MP08_0238 Preferred Project Report

88 Walker Street and 77-81 Berry Street, North Sydney Proposed Commercial Tower and Hotel Building

Submitted to
Department of Planning
On Behalf of Eastmark Holdings Pty Ltd

October 2009 ■ 08510

Figure 3 – The shadow increments between 2.50pm and 3.00pm in midwinter

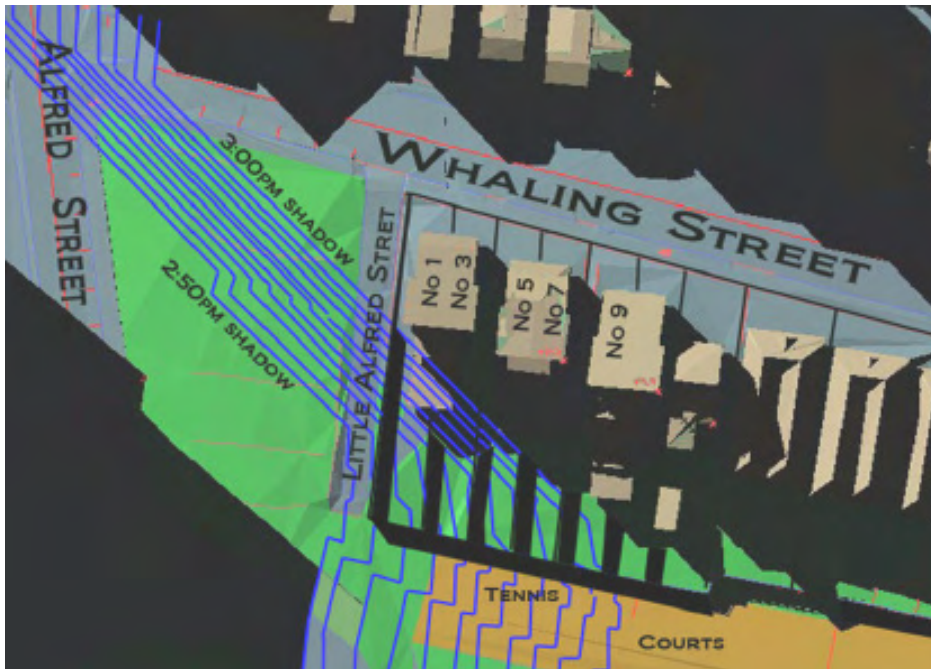
In order to further demonstrate that the proposed development will not have an unacceptable overshadowing impact on any property zoned for residential purposes outside of the CBD, PSN Matter were commissioned to undertake a detailed shadow analysis of the properties at the western end of Whaling Road (refer **Appendix D**).

Figure 3 illustrates that the properties at the western end of Whaling Road are only affected for up to a maximum of 8 minutes late in the afternoon around June 21. Those properties affected are not overshadowed by any other development to the north and receive uninterrupted sunlight from 9am onwards. The properties therefore receive well in excess of 3 hours of sunlight around June 21 – the typical standard.

Figure 18 – Proposed roof line of the towers

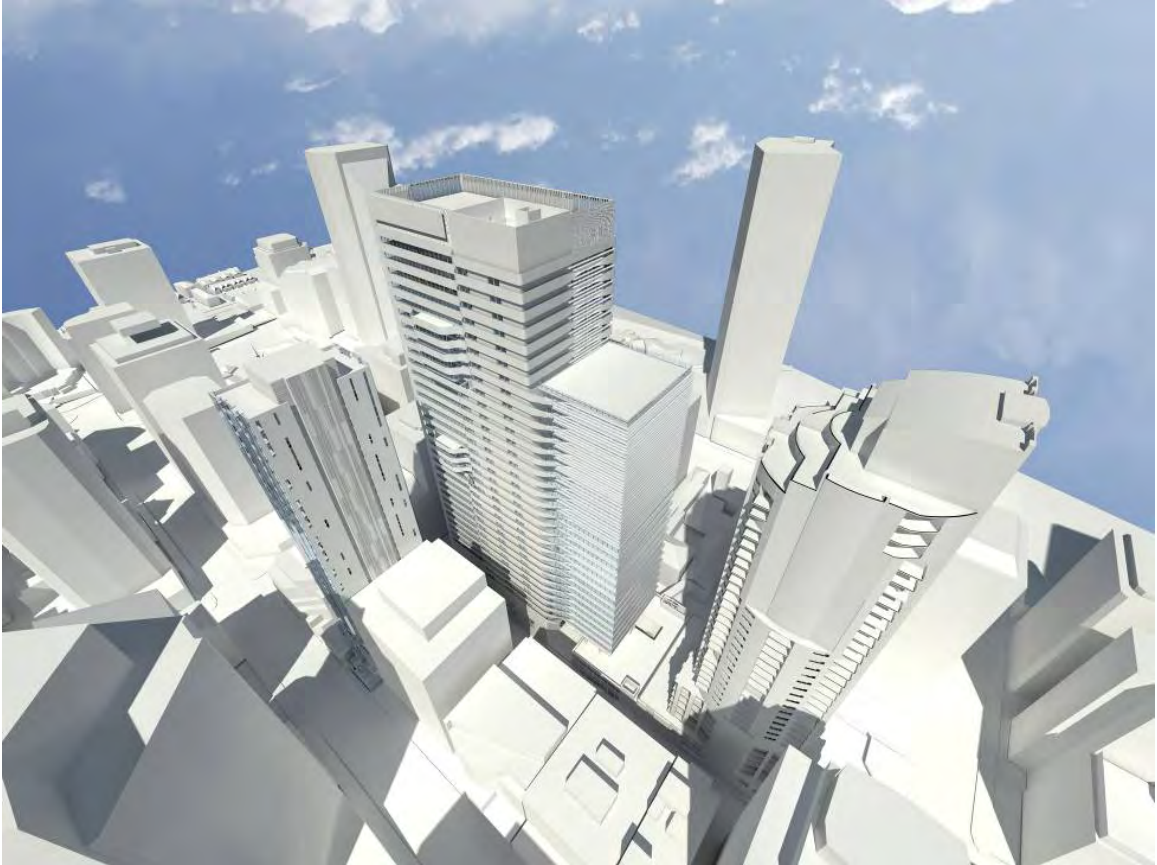
"The Department has concern with the lack of articulation and visual interest to the roofline / skyline of the main office building and requires a number of different design options to be provided. Any articulation of the skyline should have regard to the view loss and visual impacts for adjoining residents of Beau Monde."

Rice Daubney has reviewed several options in order to provide greater articulation to the roofline of the commercial and hotel buildings. For the commercial building greater articulation of the roof is achieved by expressing 3 distinct elements at the top of the building. This has been achieved by

- varying the heights of the different elements of the top of the building. The top of the core is now the tallest part of the building (same overall height as the previous design);
- The plant room, which is set in line with the main tower façade, has been reduced slightly in height (about 1.2m) and is now treated with louvers within the same facade panel as the curtain wall below; and
- The screens have been set beyond the facade (previously wrapped around the entire top) and below by a further 1.2m (approximately).

With regard to the hotel building, greater articulation has been achieved by lowering the heights of the eastern and western elements of the building so as to give greater prominence to the central portion of the building and clearly articulate the northern façade into three elements with deep recesses between.

The proposed rooflines are shown in **Figure 18**.

Figure 19 – New pedestrian link connecting Walker Street and Denison Street

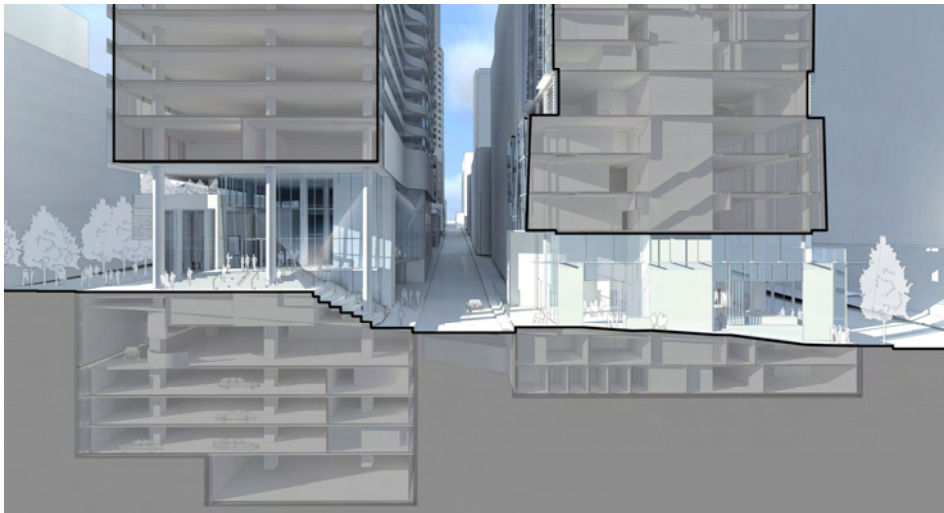
“The Department has concerns with the lack of justification for the proposed pedestrian bridge and an assessment of other alternatives, including at grade access. Further analysis including different design options is required.”

One of the most significant changes made to the proposed scheme is the deletion of the pedestrian bridge across Little Spring Street. In lieu of this, a new ground level pedestrian connection has been created along the southern boundary of 88 Walker Street (see **Figure 19**). This link will provide direct visual connection to the commercial building and will be open during normal business hours. The link potentially provides the opportunity to gain a greater appreciation of the northern boundary wall of the Firehouse Hotel.

Figure 24 – Comparison of 88 Walker Street and 126 Phillip Street

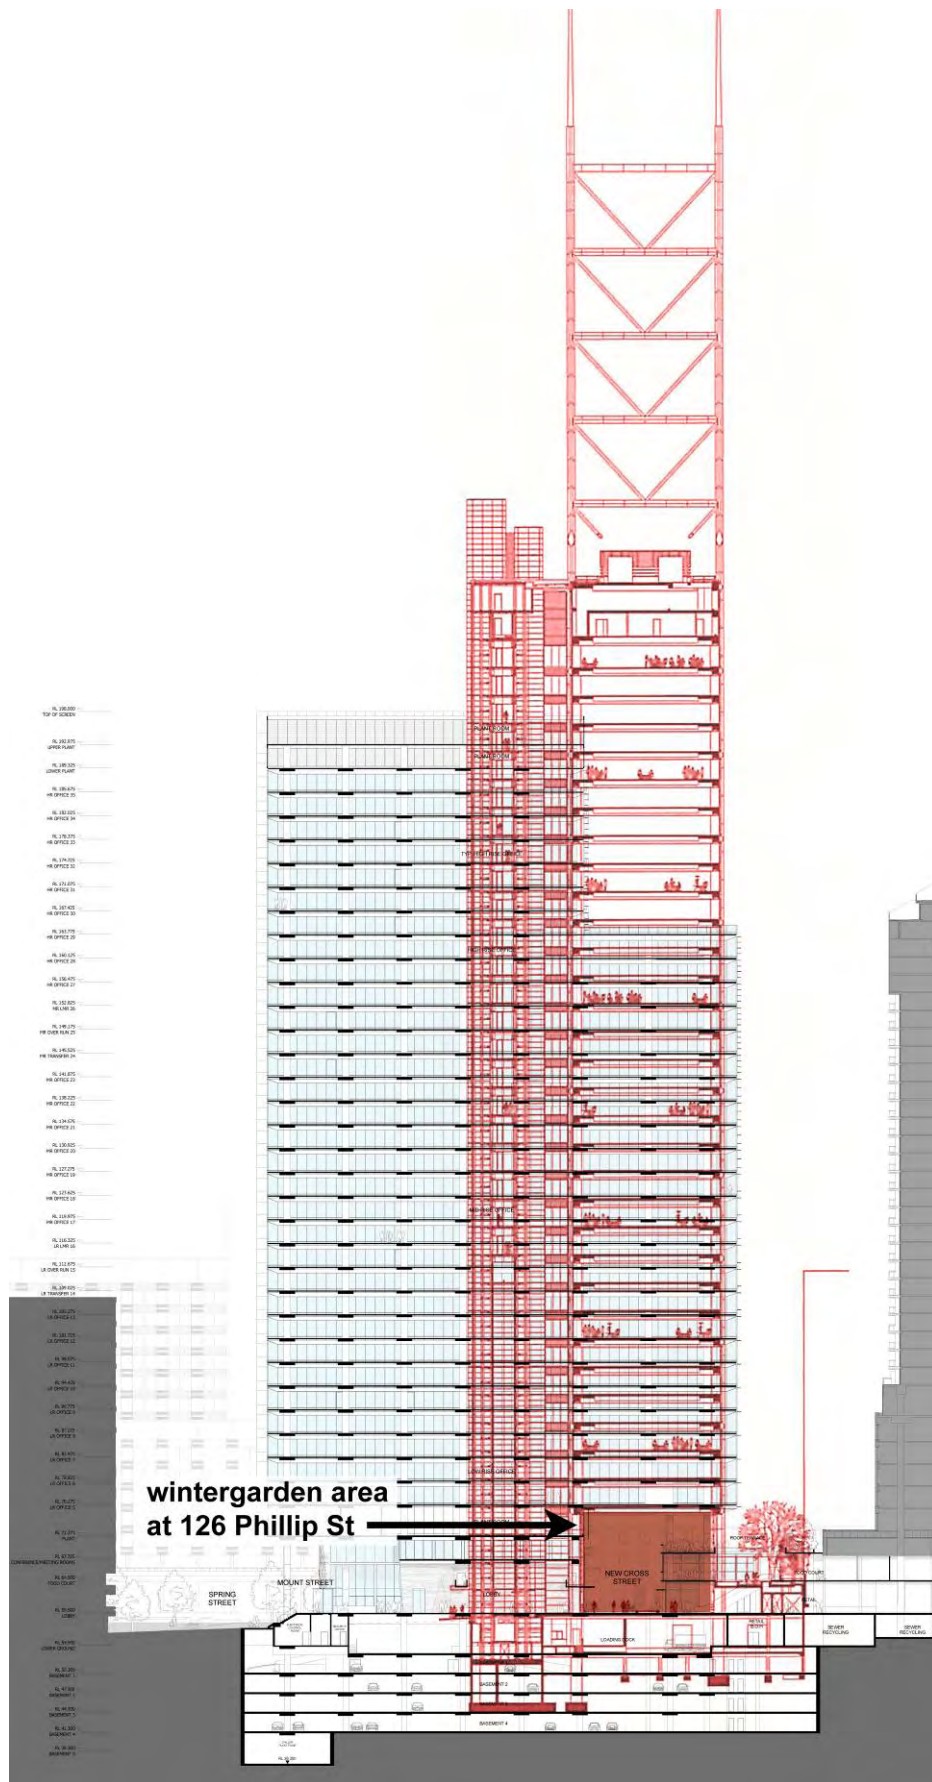
“The Department has concern with the design of the internal walls and soffit to the through site link. Further design resolution is required to improve activation of elevations at ground level and to maximise penetration of natural light.”

The through site link is approximately 16.6m high and will receive a high level of daylight. It is similar to that of 126 Phillip Street, Sydney as shown in the diagram at **Figure 24**. 126 Phillip Street is a highly regarded public space which is considered by many to provide a good example of a public space. It is noted that 126 Phillip Street is surrounded by tall CBD buildings and is more enclosed than that of the space that is proposed as part of this proposal. It is therefore likely that the proposed through site will receive significantly higher levels of daylight.

Figure 25 – Recommended ground level wind treatments

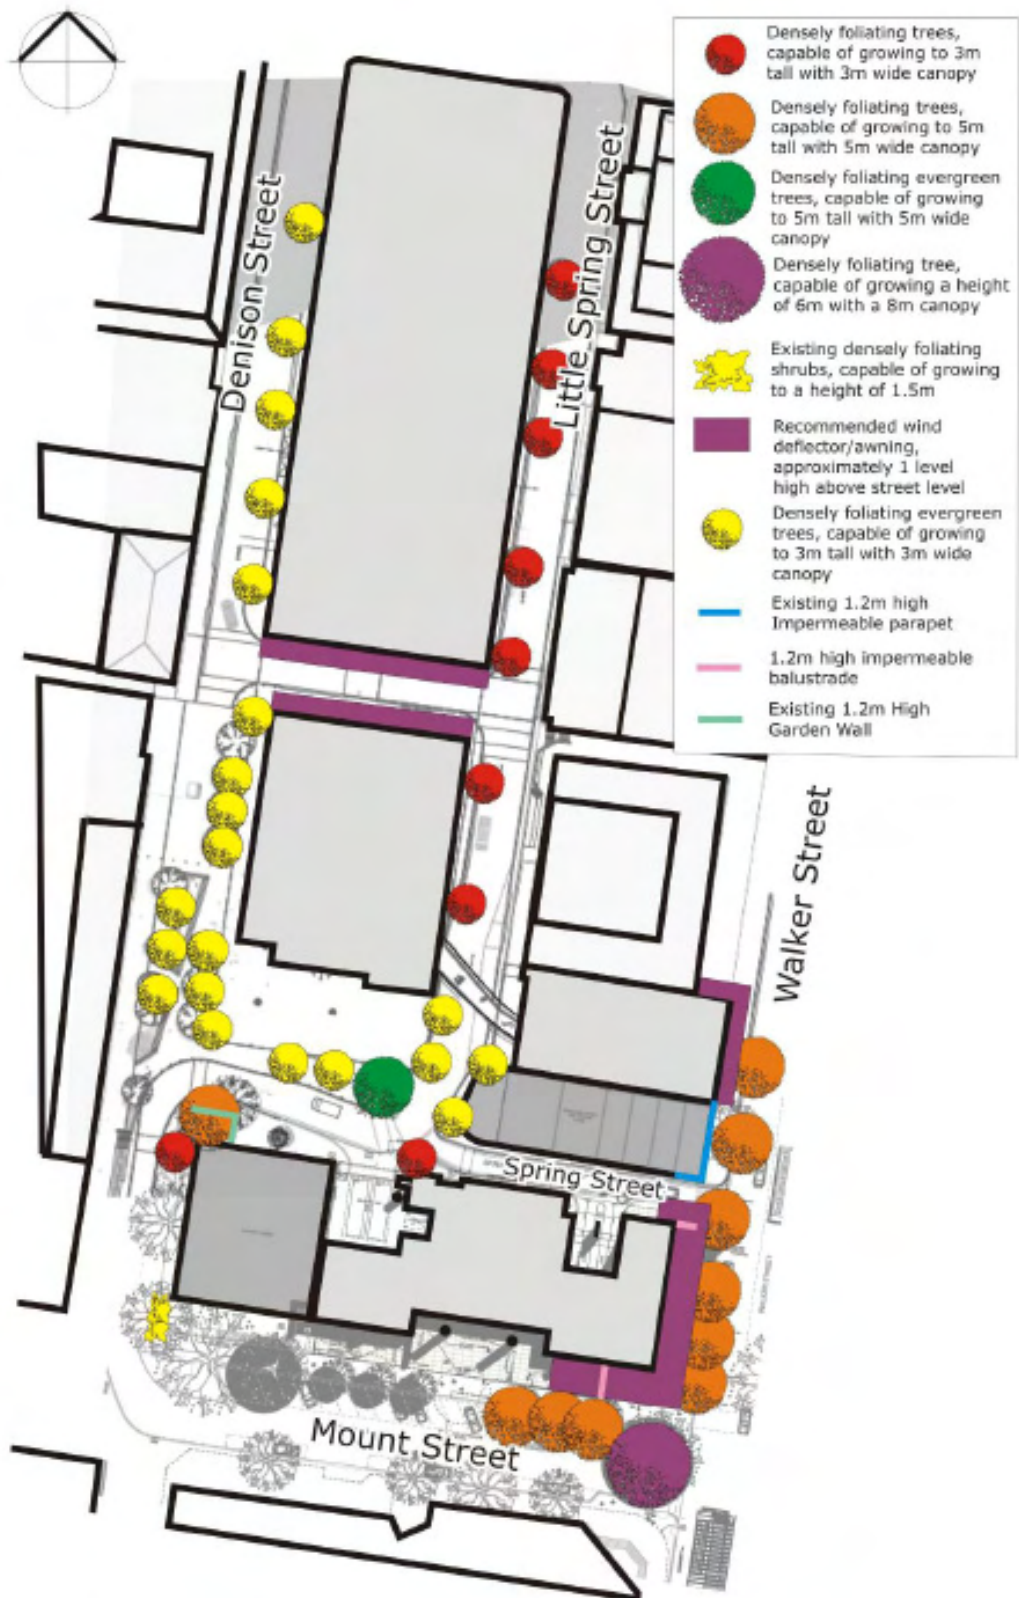
"The Department has concerns that the Wind Report prepared by Windtech Consultants Pty Ltd has not taken into account the cumulative impacts from the proposal and future developments surrounding the subject site (in particular the proposal for 86 – 96 and 100 Mount Street). The Department request the lodgement of a revised Wind Report that addresses the above matters."

"A report addressing the potential wind impacts on the southern elevation of the Beau Monde residential building and identifying any measures needed to ameliorate impacts."

The locations of the proposed wind amelioration treatments are shown in **Figures 25** and **26**. Windtech are of the opinion that with these measures in place, the proposed development will not generate any unacceptable impacts in terms of amenity of the public domain. All of the recommendations made by Windtech have been incorporated into the proposal.
